Metropolitan Coal Mine – independent review of environmental performance to 2022

Prepared by Peter Dupen, H2onestly hydrogeologist

Prepared for Nature Conservation Council of NSW (NCC), March 2023

Figure 4. Schematic showing the hypothesised causes of “ridge fracture drainage”, annotated here as basal shear planes (yellow) and sub-vertical stress relief fractures (grey). Base figure reproduced from Advisian, 2016.

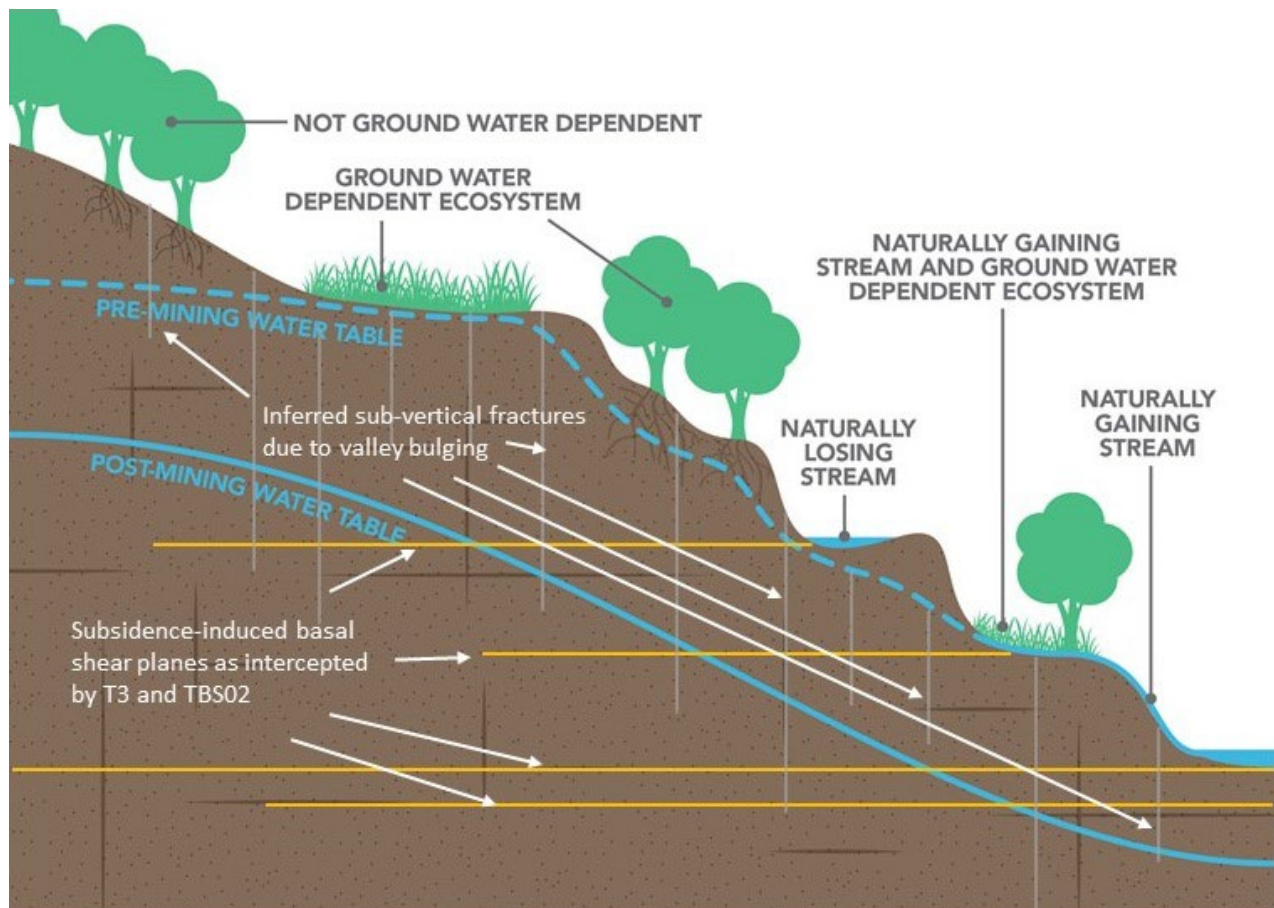
A schematic interpretation of an undermined ridgeline is shown in Figure 4, with annotations showing notional basal shear planes and sub-vertical fractures plus the influence of the reduced groundwater levels on groundwater-dependent ecosystems and/or baseflow springs along the ridge due to lowered groundwater levels beneath the ridge. For the sake of clarity, Figure 4 does not show the altered groundwater flowpaths expected to occur specifically due to the imposition of basal shear planes and interconnected sub-vertical fracturing associated with valley bulging, but these are discussed with the evidential reviews below.

2. Whilst some non-conventional valley closure effects may well have contributed, the primary cause of flow diversion is the impositions of a mechanism termed here as “ridge fracture drainage” (Figure 4); the opening of widespread and interconnected basal shear planes beneath the base of the valley between Pools ETAG to ETAR, combined with sub-vertical drainage along and below the ridge surfaces. If these subsidence effects are indeed substantial, ridge fracture drainage presents a risk to the catchments that has not previously been recognised, and the implications for future longwalls should be urgently re-considered.

My conclusion is that there is sufficient evidence to say that permanent, widespread mining induced changes **have** now been observed to occur in the Woronora Reservoir catchment, though not in the style that was conceptualised when the EA was being developed. We do not appear to be losing the water to underground workings, but rather the catchment's water paths are being diverted through shear zones and fractures at the base of the valleys, a phenomenon which might be termed "ridge drainage fracturing" (Figure 4).

Figure 8. Cross-section view of T1-T5 piezometer transect at Woronora Reservoir, levels as reported in the Annual Review (Metropolitan Coal, 2022a).

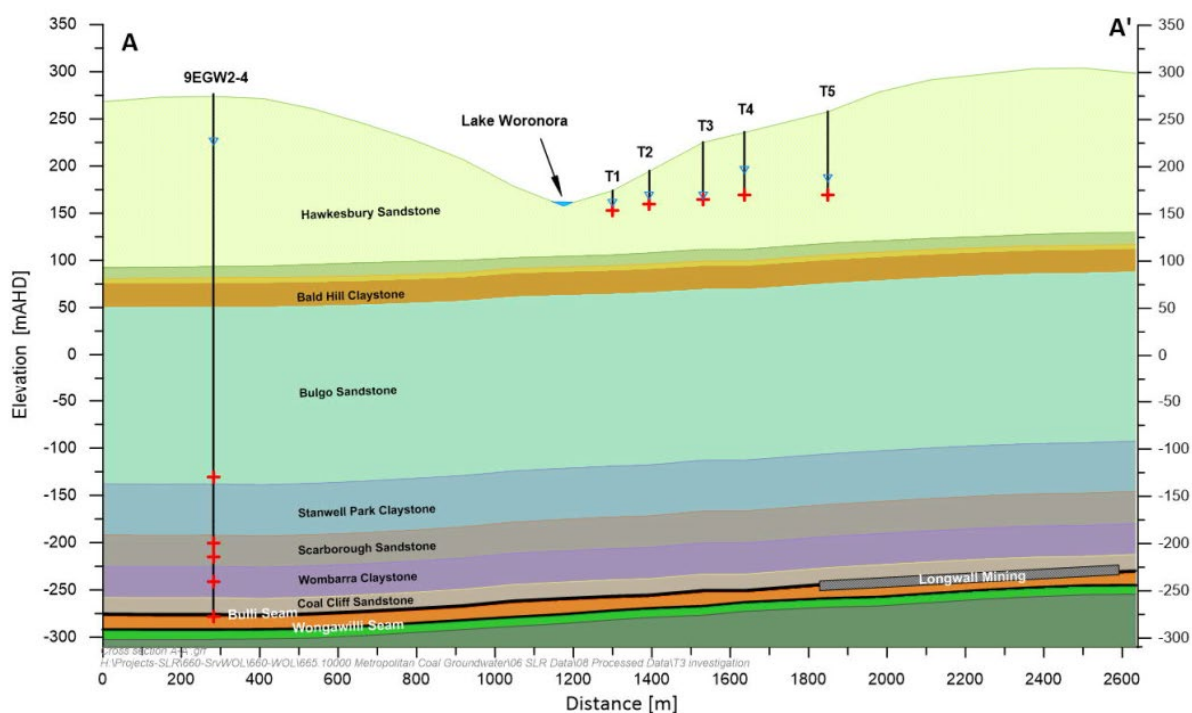
Figure 8 shows the post-mining groundwater profile in the “transect piezometers” (T1-T6) in late 2020. All of these piezometers are located within the upper aquifer, locally represented by Hawkesbury Sandstone, adjacent to stored reservoir waters.

The most disturbing trend however, is that the levels in T3 dropped below its base 17 days after the commencement of Longwall 305 (Figure 3), and then sheared in December 2020 (Figure 9). The piezometer was replaced in 2021 by a deeper one at the same location (T3-R). As can be observed by the red trace in Figure 9, groundwater responses in T3/T3-R appeared sensible for its ridge position prior to mining but now the water table closely mimics the reservoir level.

The much more likely, and now virtually indisputable, conclusion from the groundwater response at this location is that the base of the original T3 piezometer was sheared by, and that T3-R now intercepts, a basal shear plane which now forms a rapid hydraulic connection to the reservoir, i.e. a groundwater drain at or around the valley’s base which extends over 250 m beneath the ridge from the reservoir (see Figure 3 and Figure 8)

Figure 9. Groundwater levels recorded in Transect Bore Piezometers, from Metropolitan 2021 Annual Review

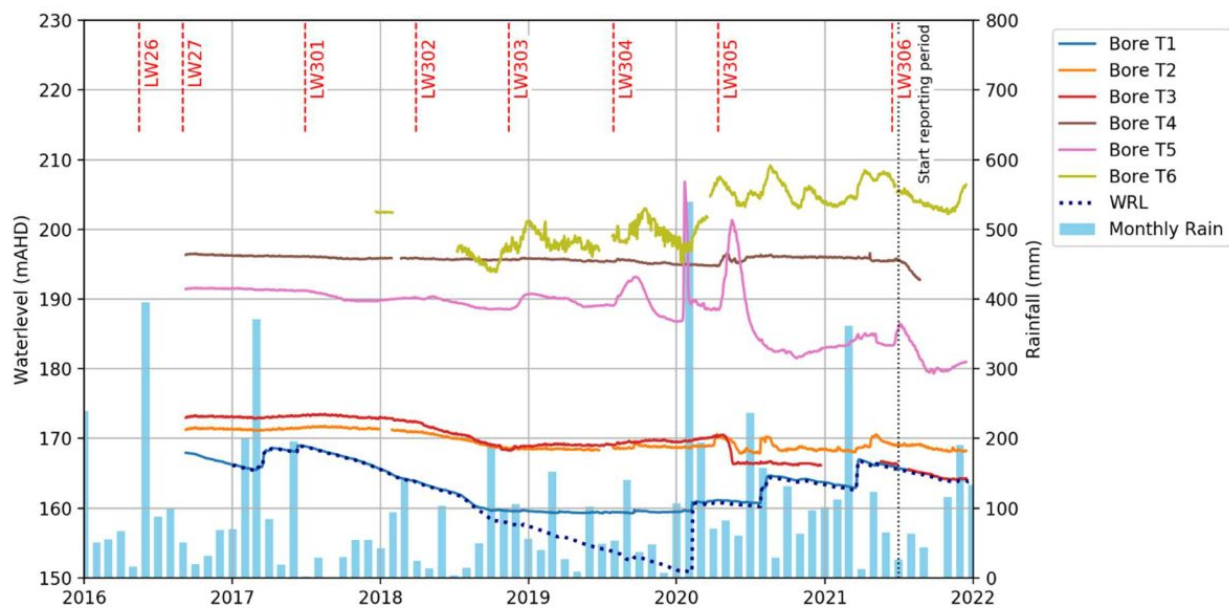
Valley (Figure 3 and Figure 8). The reported (Metropolitan Coal, 2022) groundwater level records in each piezometer are presented in Figure 9.

Figure 12. Monitored and model-predicted flows – Eastern Tributary upstream of Woronora Reservoir

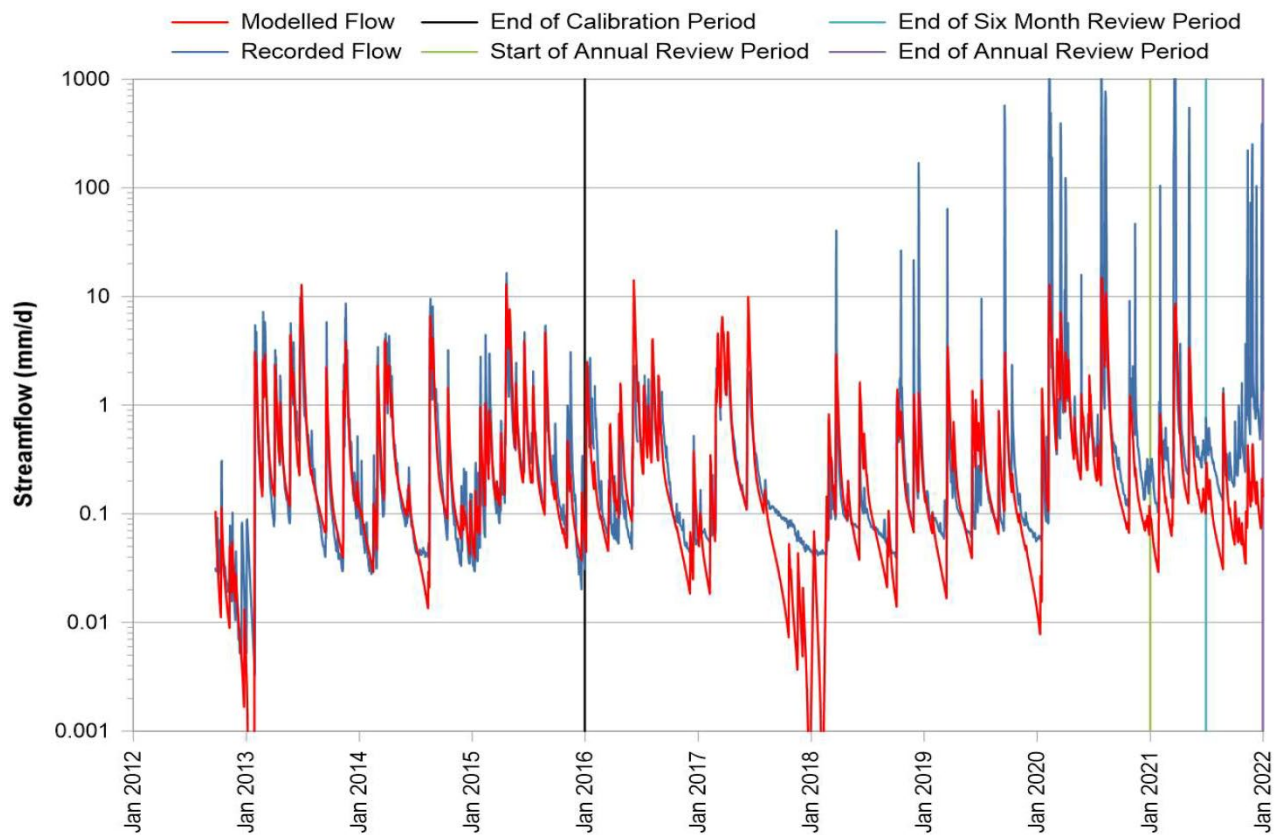
Despite being diverted through a subsurface fracture network for about 500 m of its upstream length, the measured flows (blue line in Figure 12) which reappear at the lower end of the stream channel have, until recently, remained surprisingly consistent with flows predicted using pre-mining, above-ground flow records (red line in Figure 12).

This conceptual model could also explain why the flows in the 2021 Annual Report period have significantly and increasingly exceeded model flows since mid-2020 (Figure 12). Where present the subsidence-induced basal shear planes are likely to now be acting as lateral drains, allowing shallow groundwater in the Hawkesbury Sandstone ridges to rapidly (by local standards) migrate towards the valley axis.

Figure 14. Conceptual model of rockbar through-flow presented in MSEC (2008).

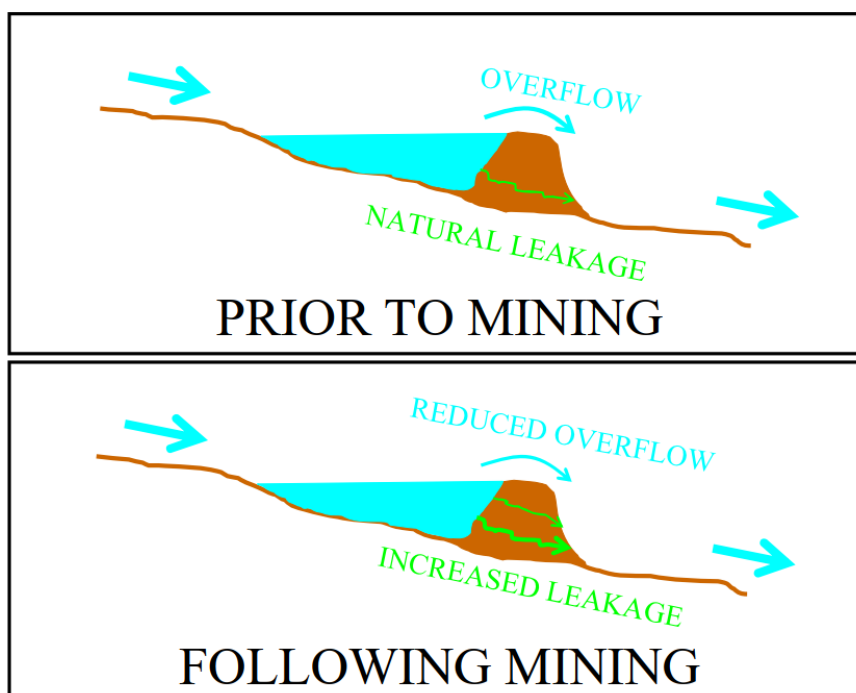
- There is little evidence that the Eastern Tributary pool drying event may be attributed to “rock-bar throughflow”, as envisaged by Peabody’s consultants (Figure 14). This mechanism, in which water in an upstream pool is able to seep through the fractured fabric of the intervening rock bar (e.g. the sub-vertical rock face in background of Figure 10), was a frequently observable feature of the subsidence impacts which occurred in Waratah Rivulet in the early 2000’s (Advisian, 2016). It is worth noting that, if shear planes have indeed been widely developed beneath the valley axis as hypothesised in Section 3.2, the remedial design that was used with considerable success at Waratah Rivulet may not be successful in restoring surface flows to Eastern Tributary.

In other words, Peabody's hydrogeologists envisaged a zone of compressive fracturing centered on the stream base, with a radius of up to 20 m of possibly interconnected fractures was the predicted landscape response to the modeled closure movements across the undermined valleys.
